# MISSOURI 2019 AIRPORT LIGHTING PACKAGE

## WEST PACKAGE

## ADDENDUM NO. 1

November 2, 2020

VAULT ENCLOSURE  
PLAN AND DETAILS

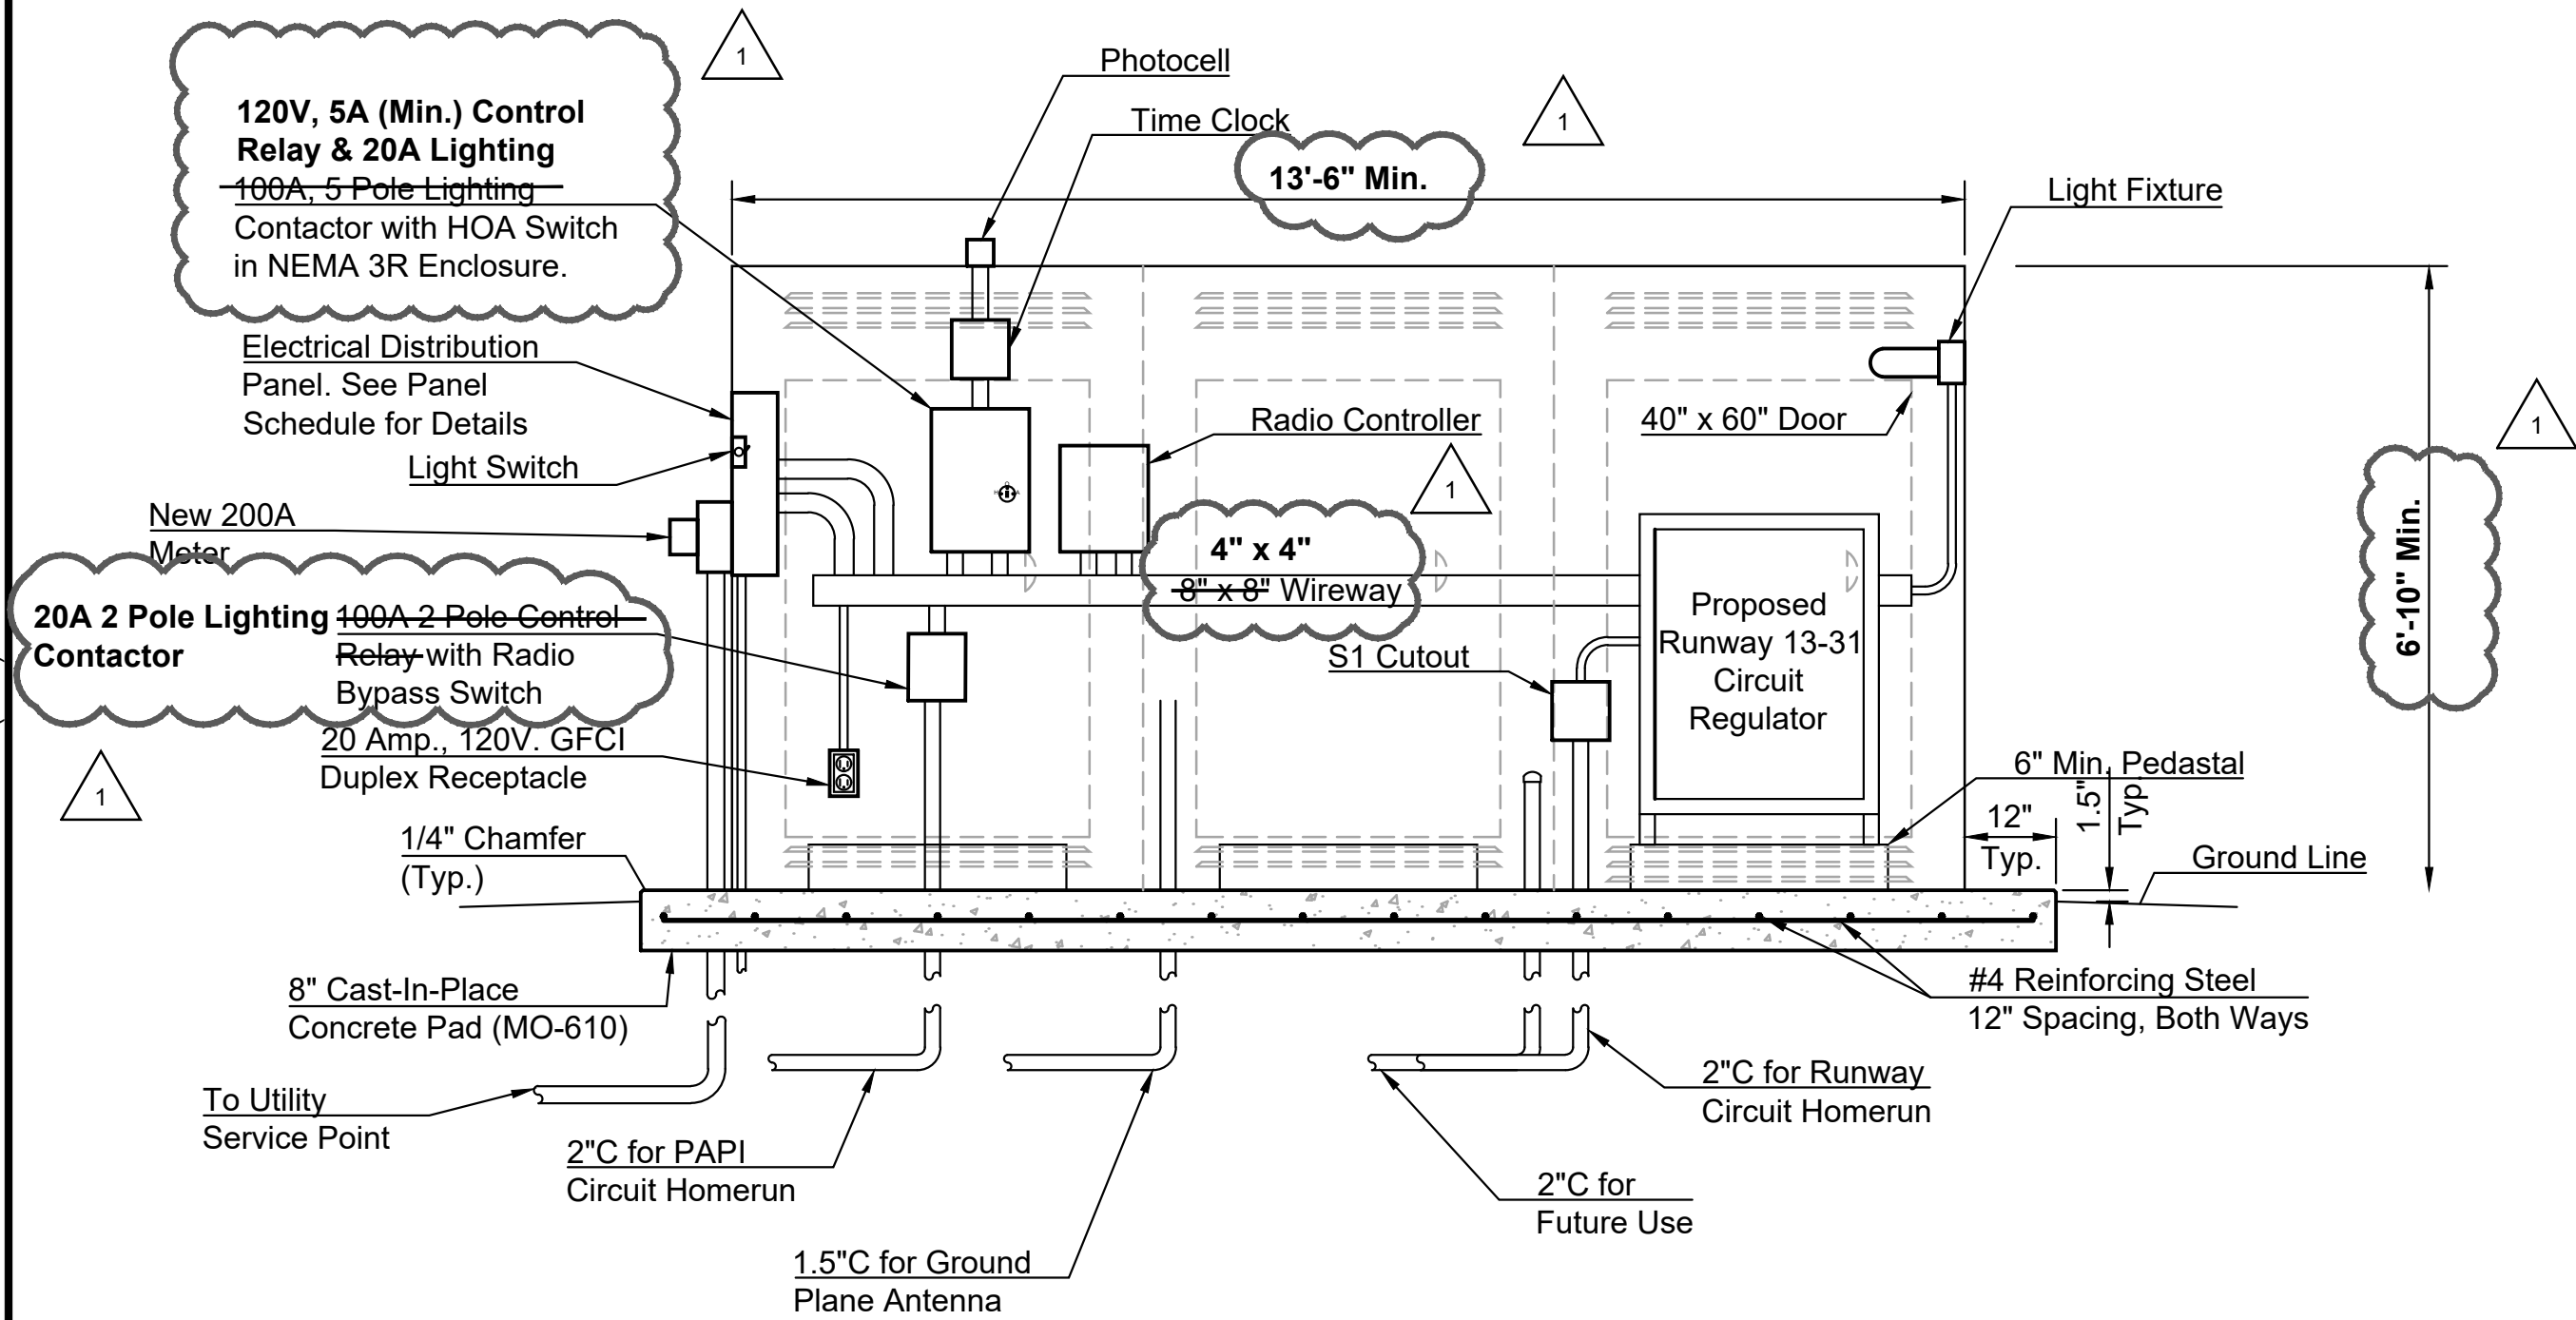
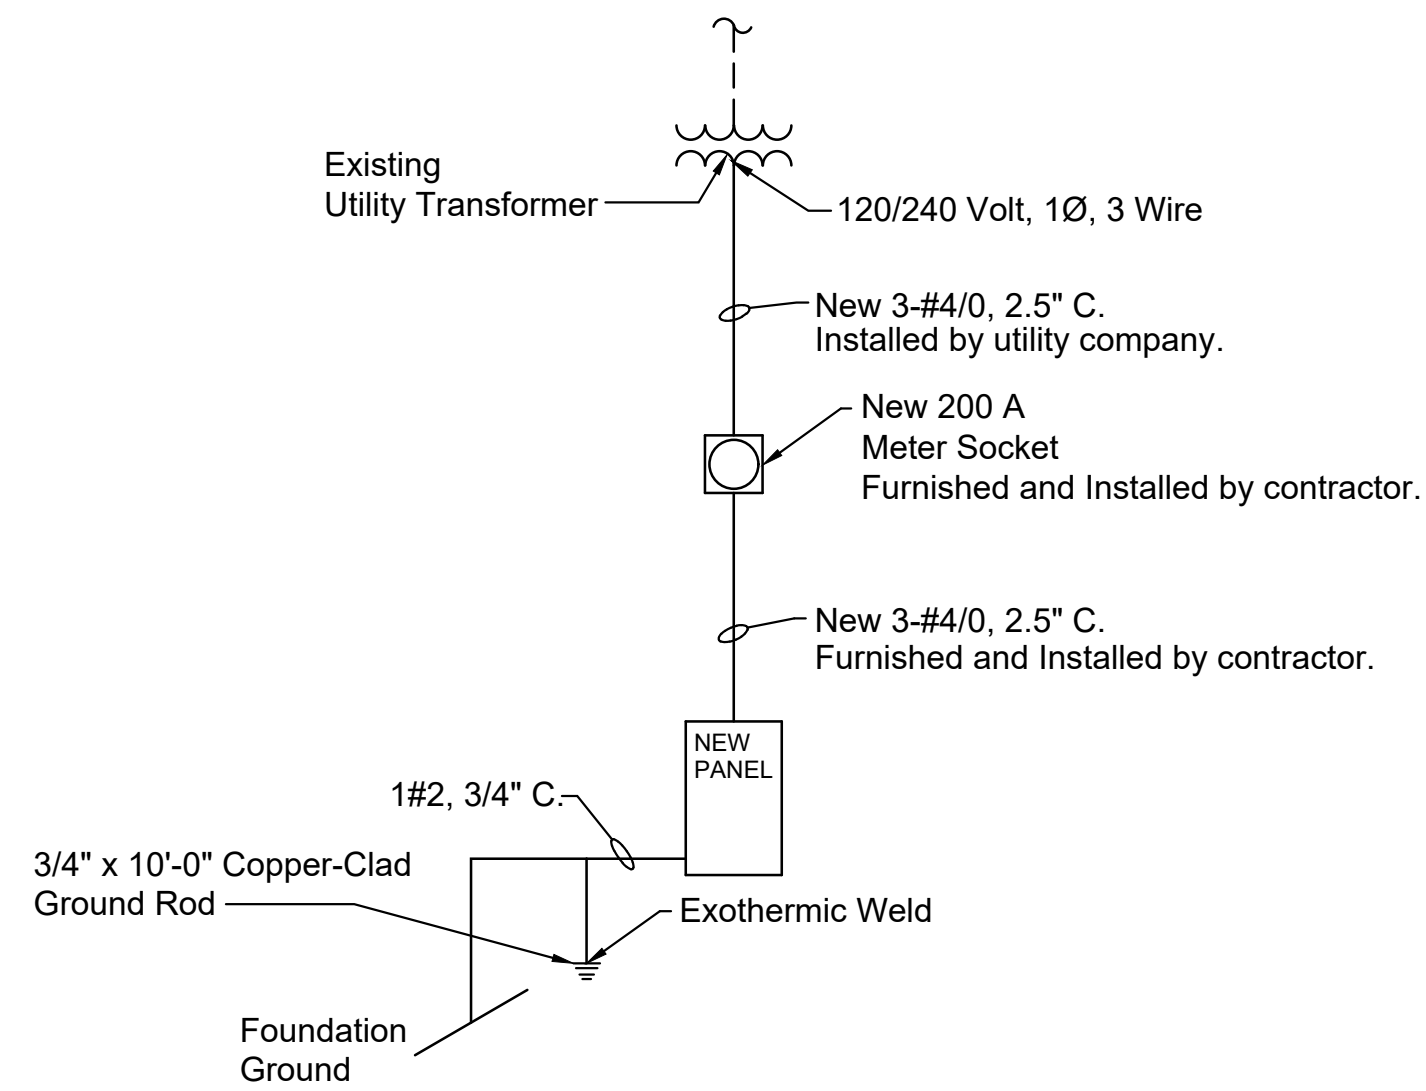
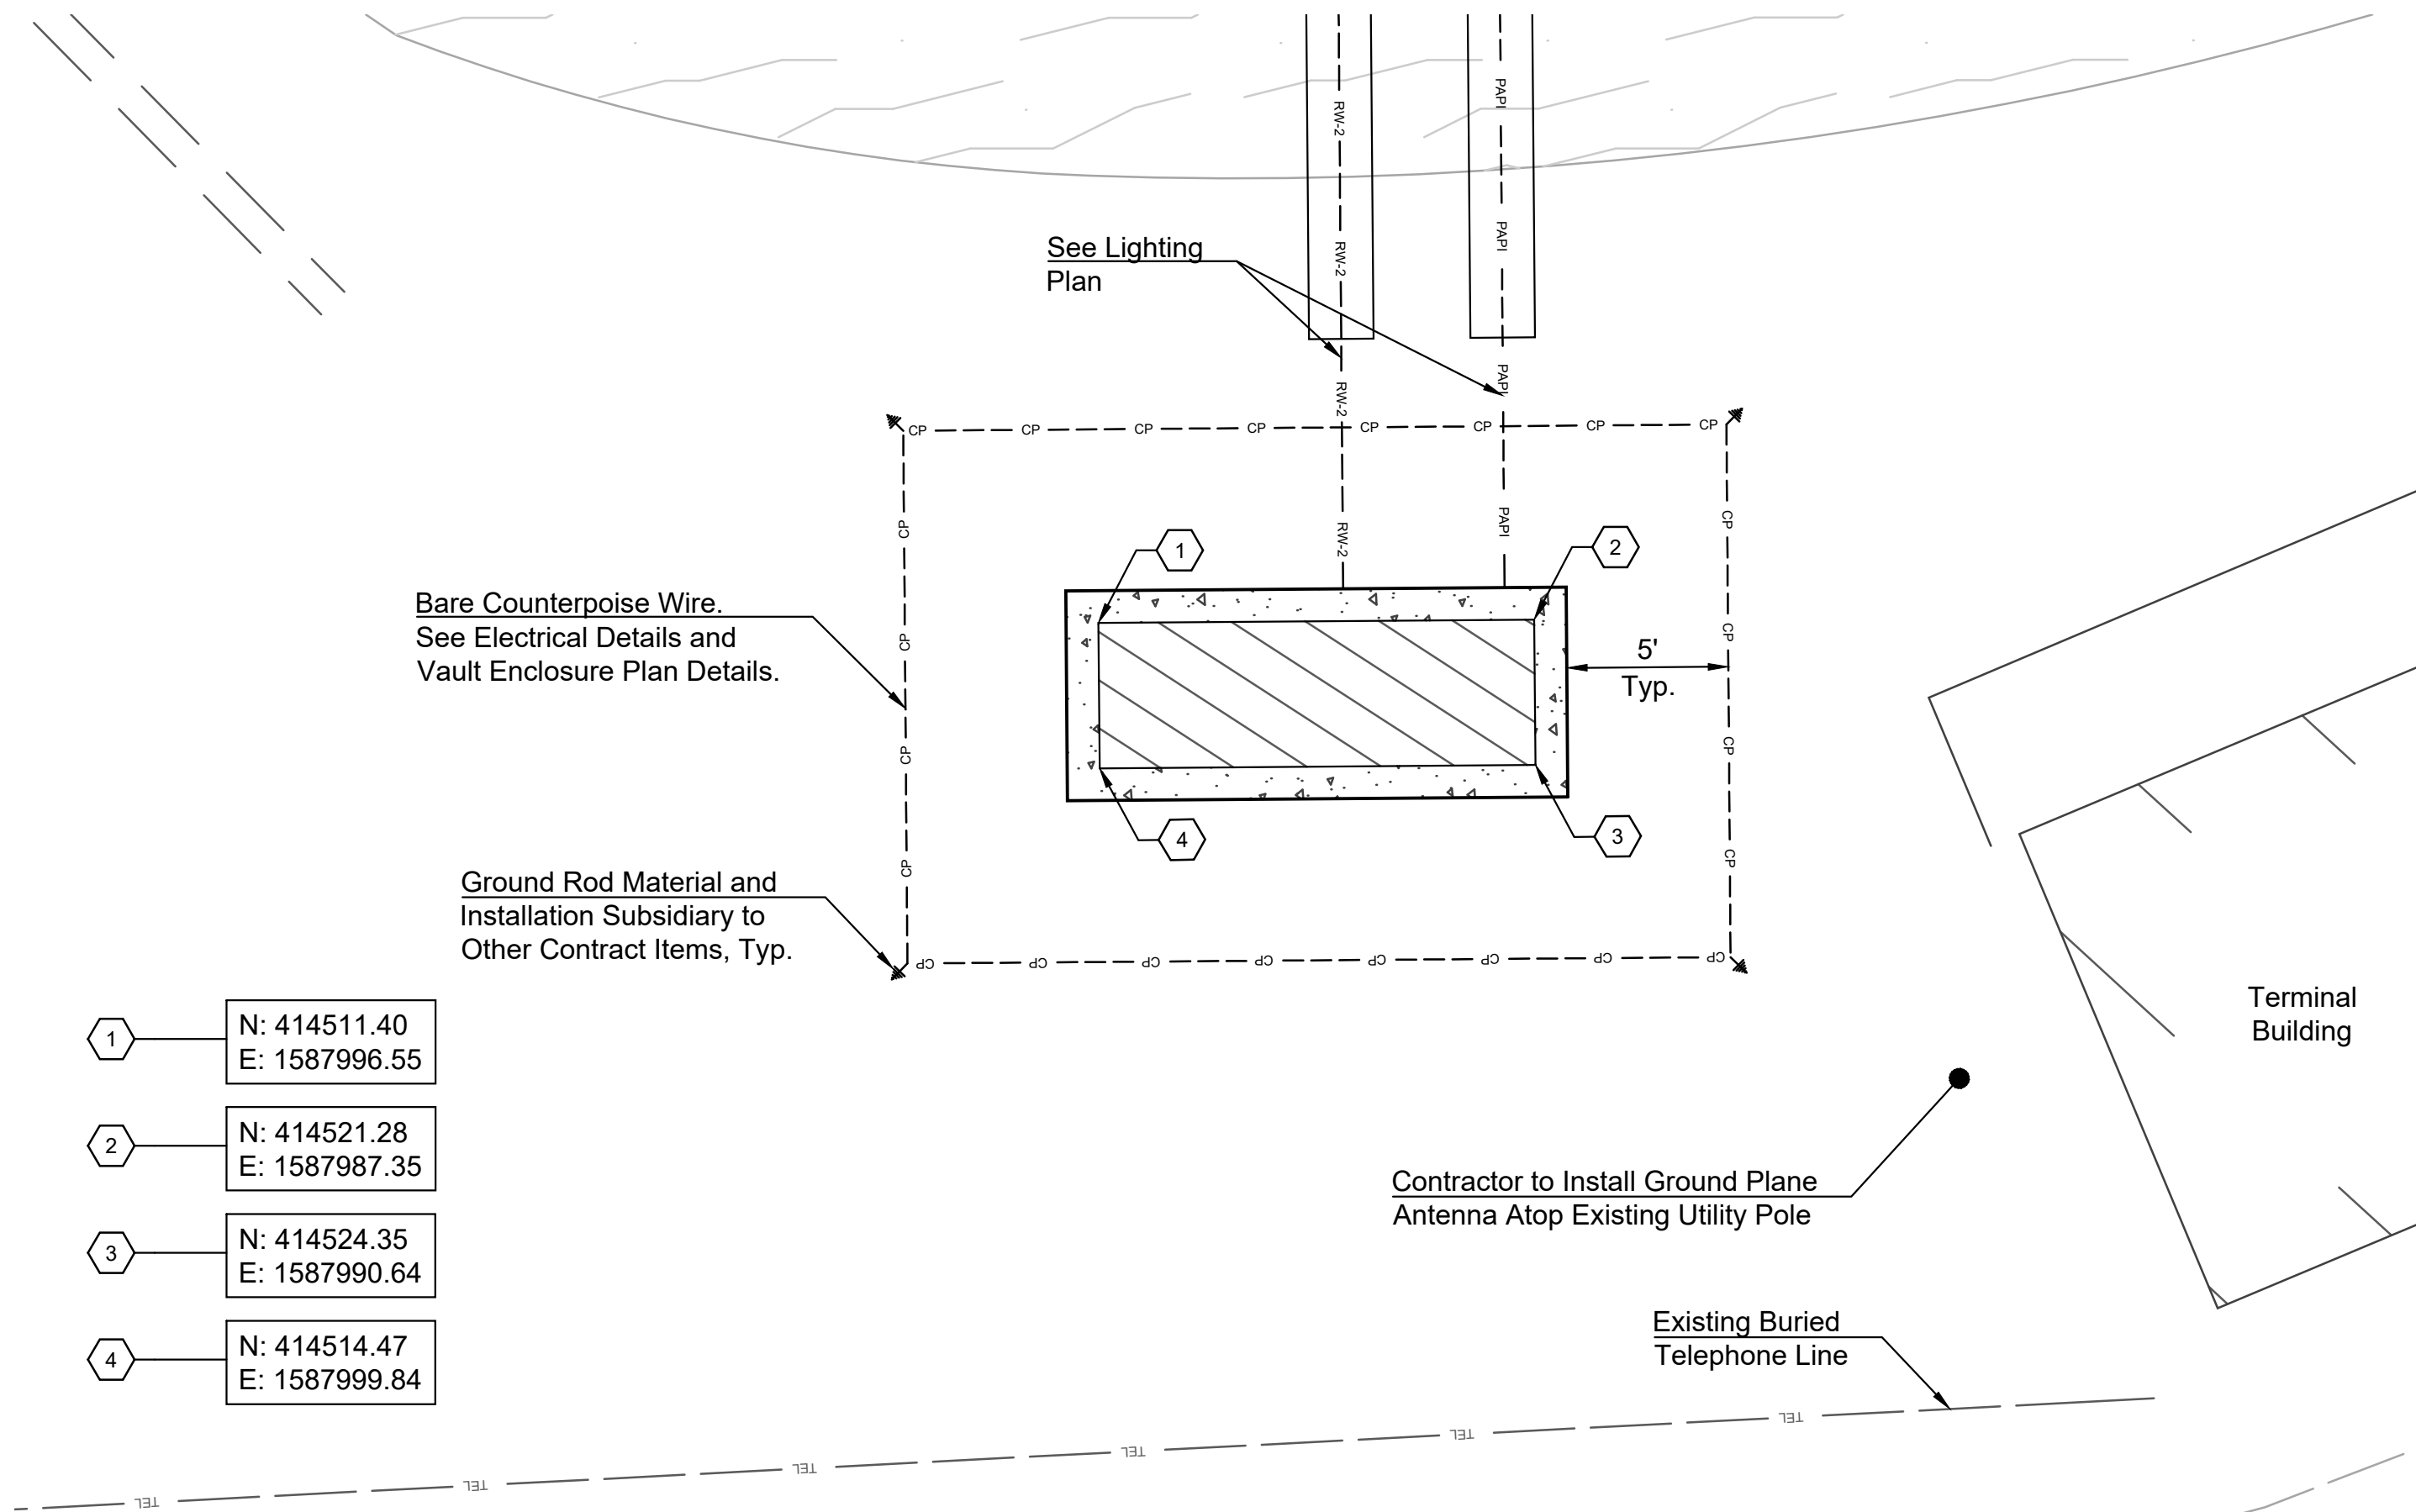
7. **Schedule D: Ava Bill Martin Memorial Airport**, Sheet No. 14 Vault Enclosure Plan and Details. The vault height (6'-10" minimum) and length (13'-6" minimum) were added to the vault enclosure elevation detail. The 8" x 8" wireway is now a 4" x 4" wireway. The 100A lighting contactor for the regulator, was removed. The regulator will now be controlled via a 120V, 5A (minimum) control relay. The PAPI control relay is now a 20A, 2 pole lighting contactor.
